Project Name: Post Oak - HVAC

Project No.: 221125-050

**END OF ADDENDUM NO. [#2]**

POST OAK HVAC  
IMPROVEMENTS  
LANSING SCHOOL DISTRICT  
2020 Post Oak Ln, Lansing, MI 48912

A1.1: First Floor Plan – Unit 100, Door and Louver Schedules, Window Types (Re-issued):

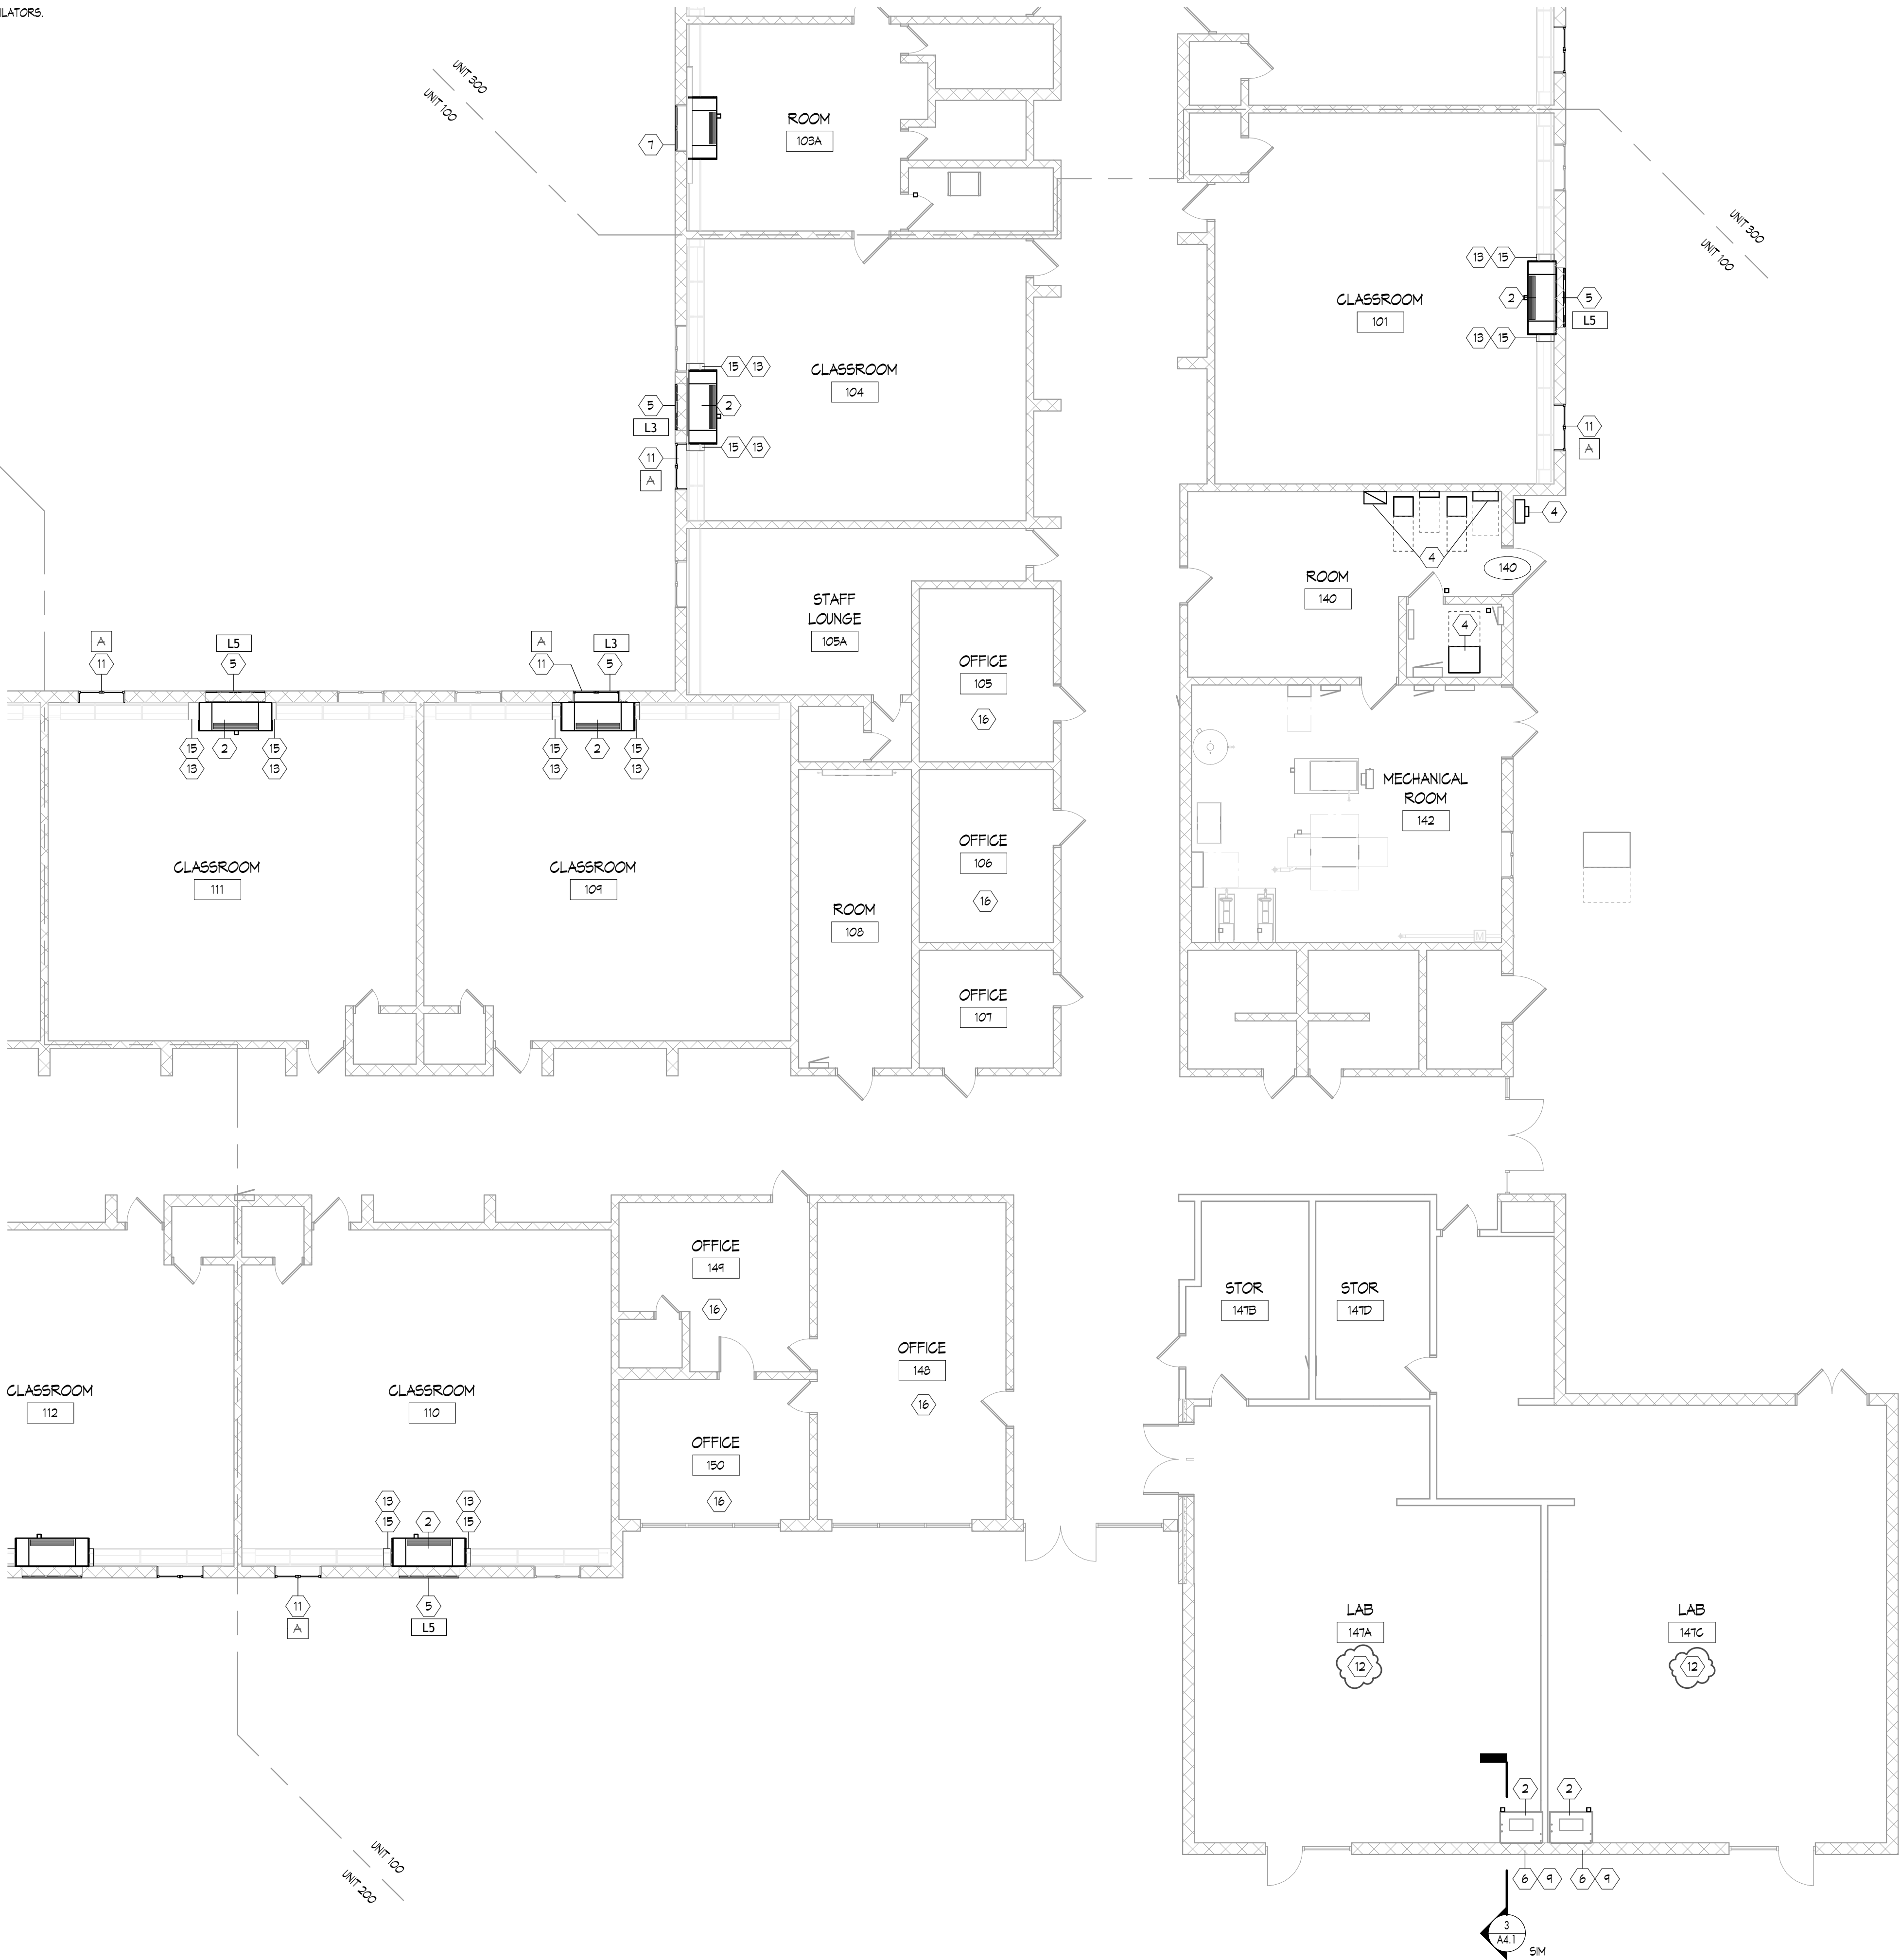
- Removed Keynote #14 in Lab 147A and 147C. Added Keynote #12.

### FIRST FLOOR POWER DEMOLITION PLAN - UNIT 100

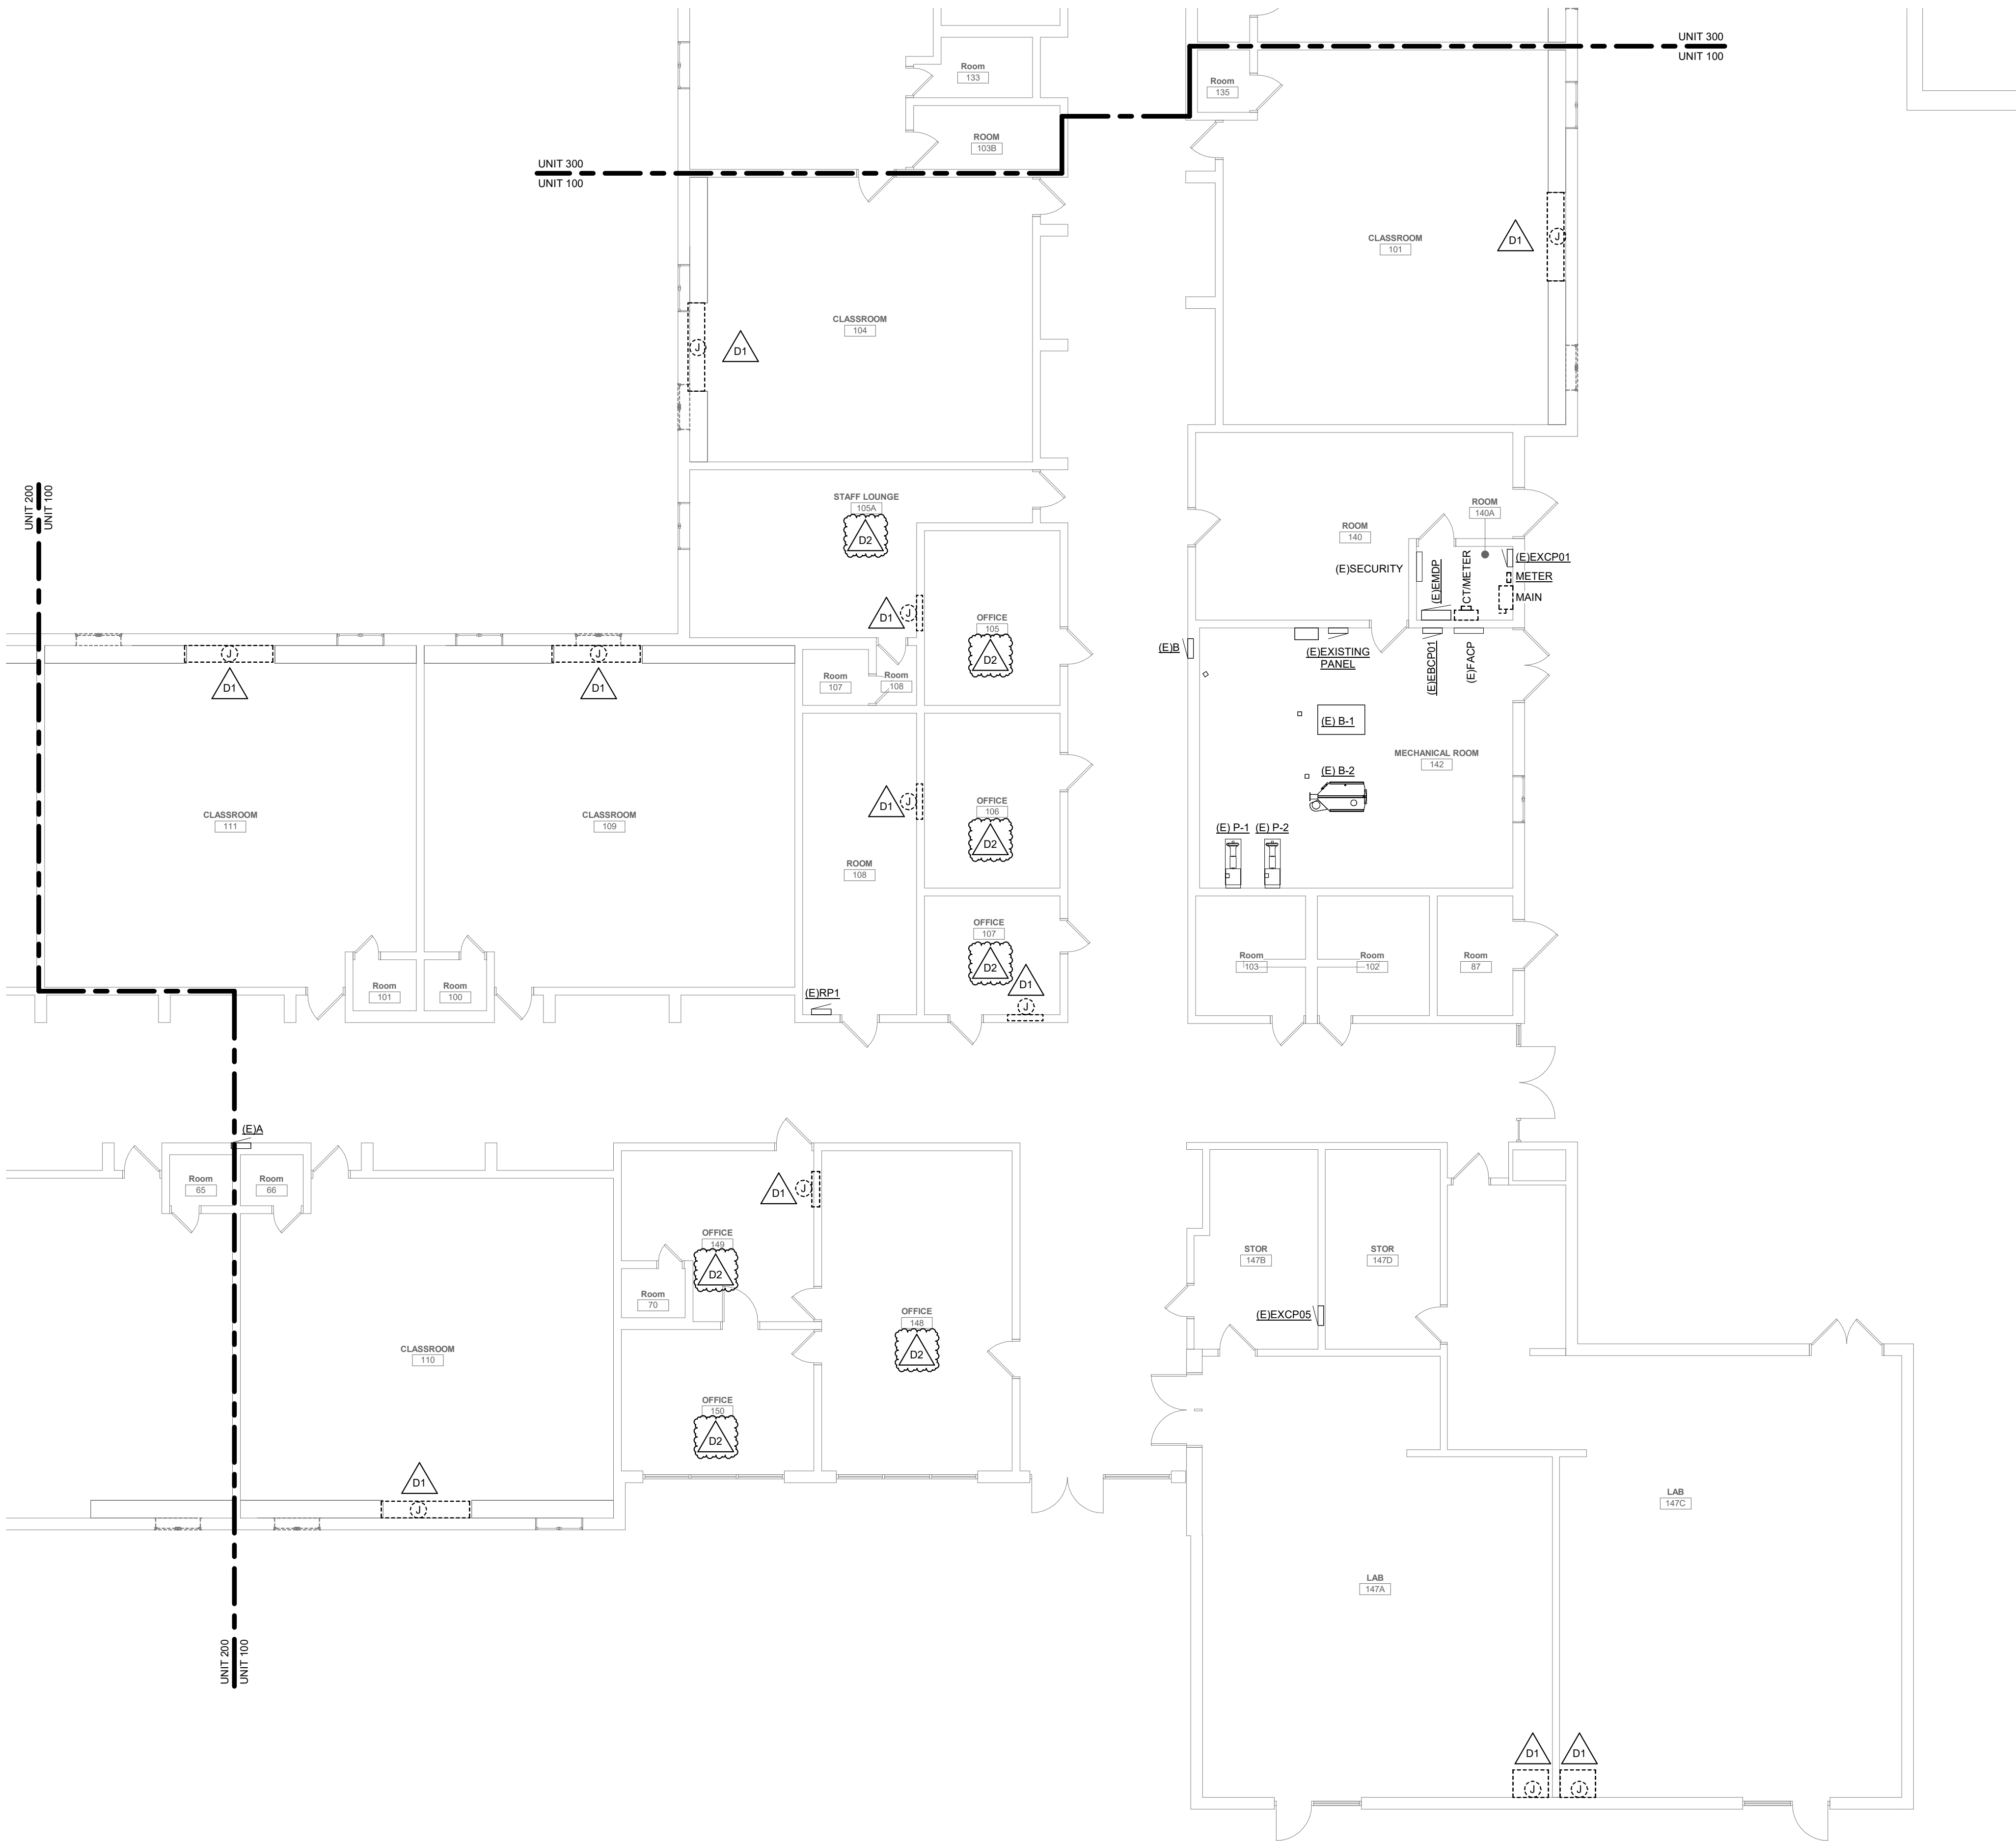
ED1.1: First Floor Power Demolition Plan – Unit 100 (Re-issued)

- Revised keynote D2.
- Added keynote D2 to office areas where indicated.

FIRST FLOOR POWER DEMOLITION PLAN - UNIT 200  
SCALE: 1/8" = 1'-0"

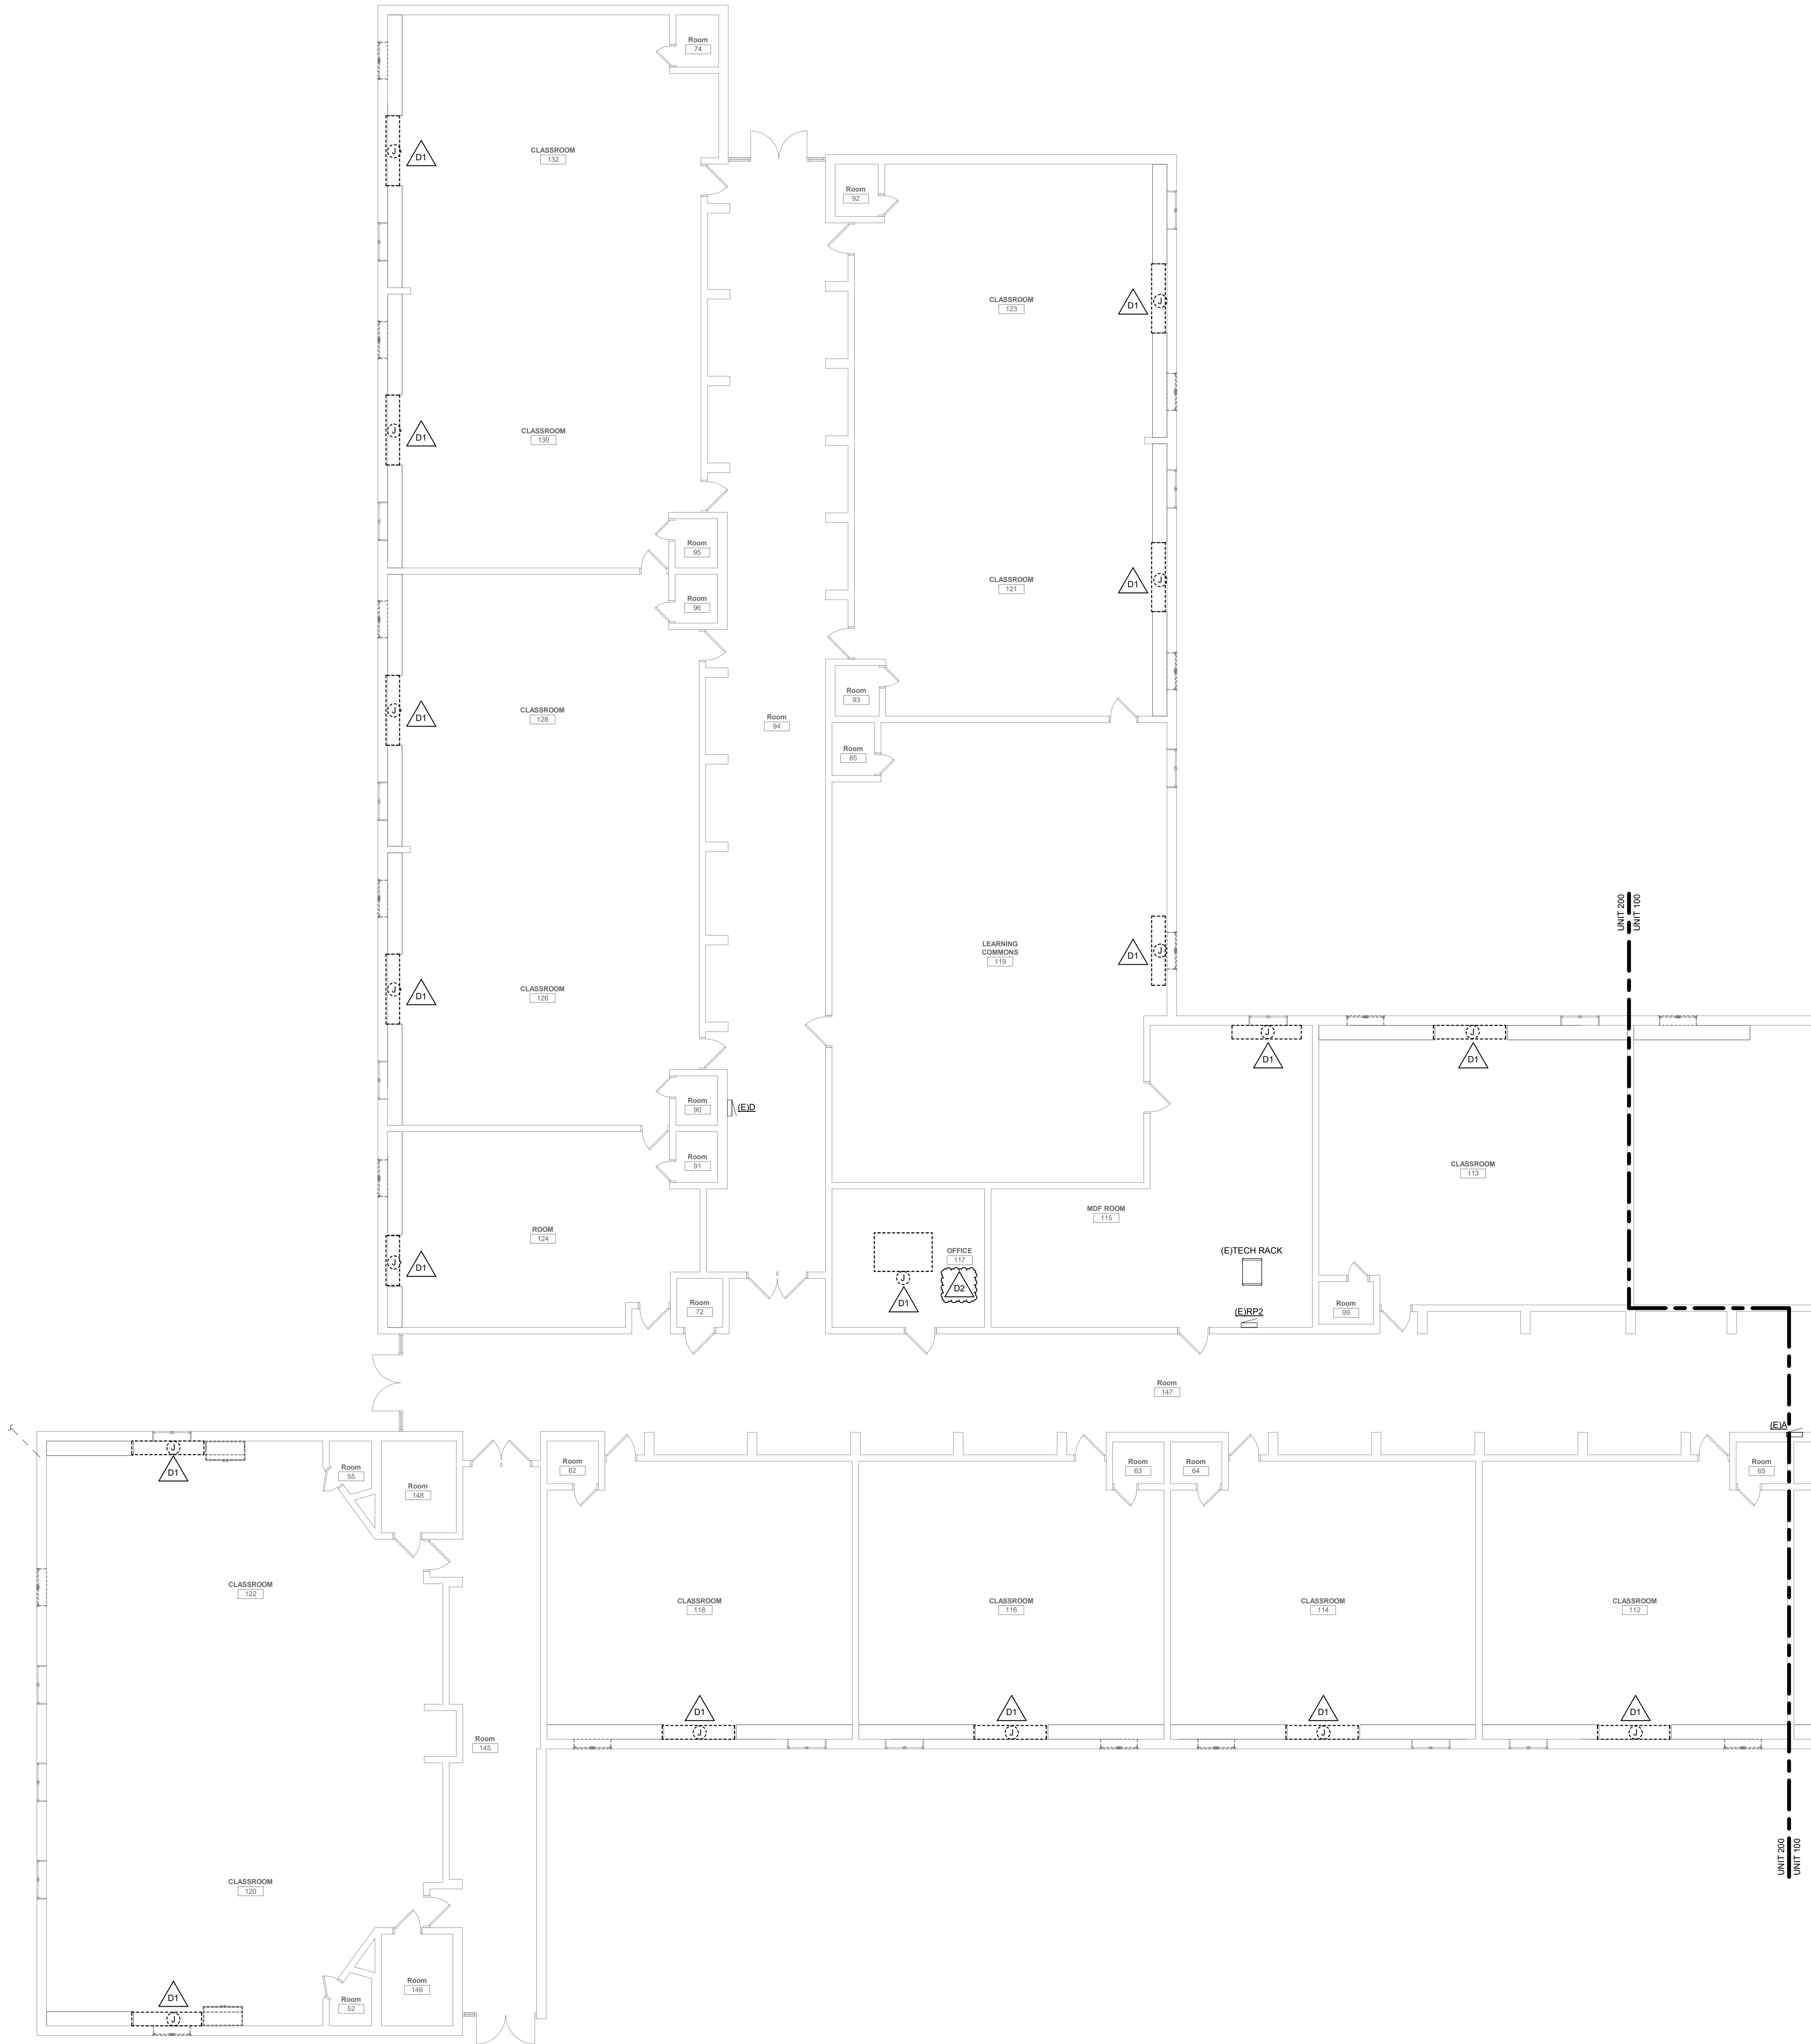
ED1.2: First Floor Power Demolition Plan – Unit 200 (Re-issued)

- Revised keynote D2.
- Added keynote D2 to office areas where indicated.
